SLR Ref No.: 620.041535.00031-L01-Camperdown RFI Response-v1.0-20260610

RE: Response to Request for Further Information – Cover Letter
Planning Permit Application PA2604198
Camperdown BESS – Wire Lane, Camperdown VIC 3260

2.0 Section 50 Amendment

The Development Plans, Planning Report and all supporting technical documentation have been updated to reflect these changes. Refer to Table 2 for a comparison of the previous and revised development specifications. Refer to Figure 1 and Figure 2 for the previous and revised Plans, respectively.

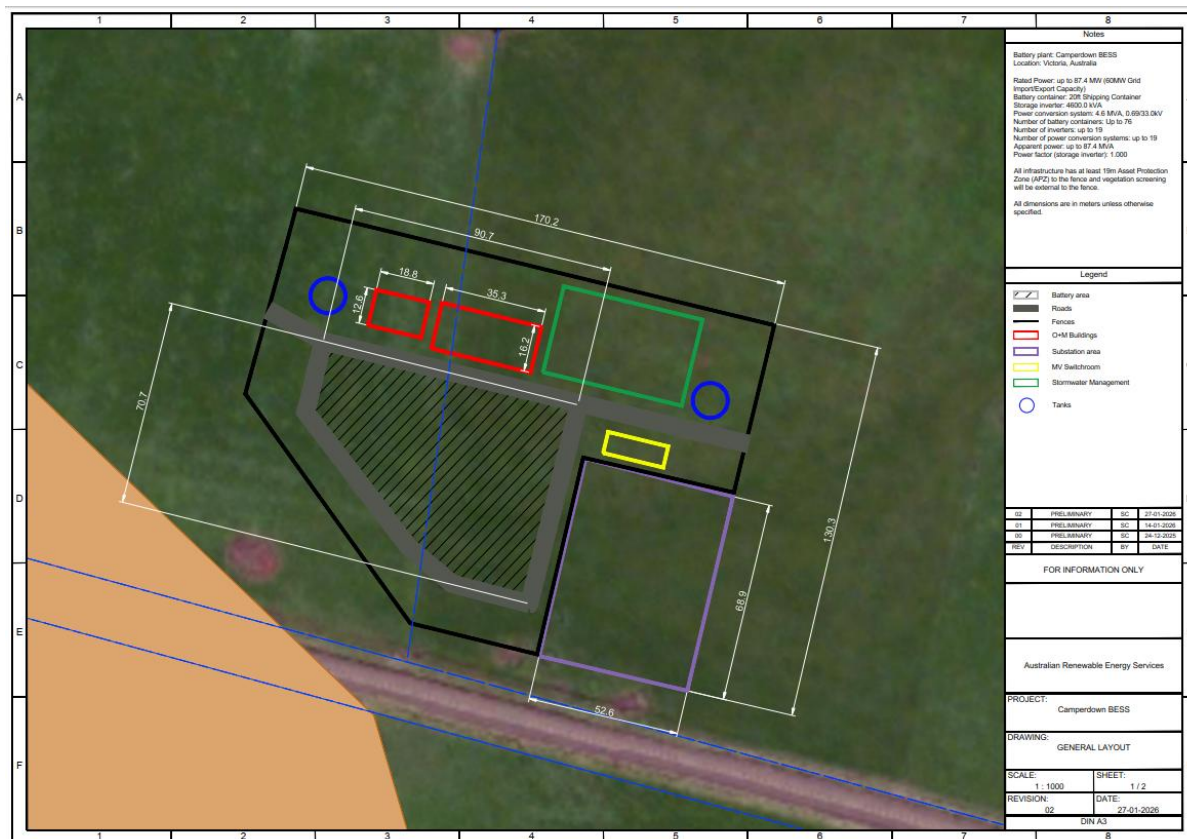
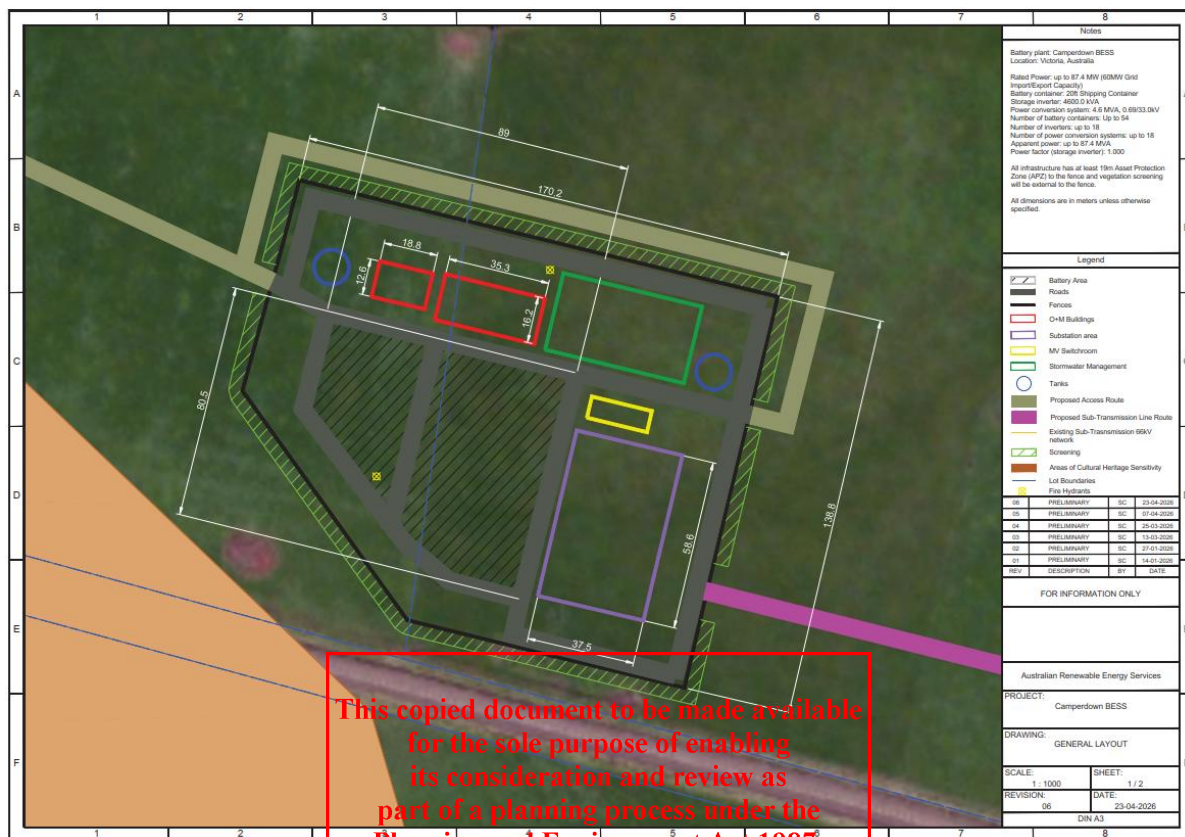
- Removal of one (1) battery container per enclosure, resulting in a total of up to 54 battery containers and a revised battery rack ratio of 1 inverter to 3 batteries.
- Removal of one (1) inverter and associated batteries, reducing the total to 18 inverters.
- Inclusion of a 5m wide landscape screening area along the entire perimeter of the Project Area
- Provision of additional internal roads, hydrant locations, and associated infrastructure reconfiguration
- Revision of fencing to incorporate the substation within the secured area. Fencing is now incorporated around the perimeter of the Project Area.

Specification	Previous	Revised
No. of Battery Containers	72	54
No. of Battery Racks per Enclosure	4-6	3
Battery Container	20ft. Battery Energy Storage System	20ft. Battery Energy Storage System
Storage Inverter	4600.0 kVA	4600.0 kVA
Power Conversion System	4.6 MVA, 0.69/33.0kV	4.6 MVA, 0.69/33.0kV
Dimensions	L: 6058mm x W: 2438mm x H: 2896mm (20 foot high cube shipping container)	L: 6058mm x W: 2438mm x H: 2896mm (20 foot high cube shipping container)
Weight	<18t	<18t
Battery Chemistry	Lithium-iron-phosphate	Lithium-iron-phosphate

Specification	Previous	Revised
Inverters	19	18
MV Transformers	19	18
Substation	1 x 66/33kV transformer, 2 x 66kV lines out	1 x 66/33kV transformer, 2 x 66kV lines out
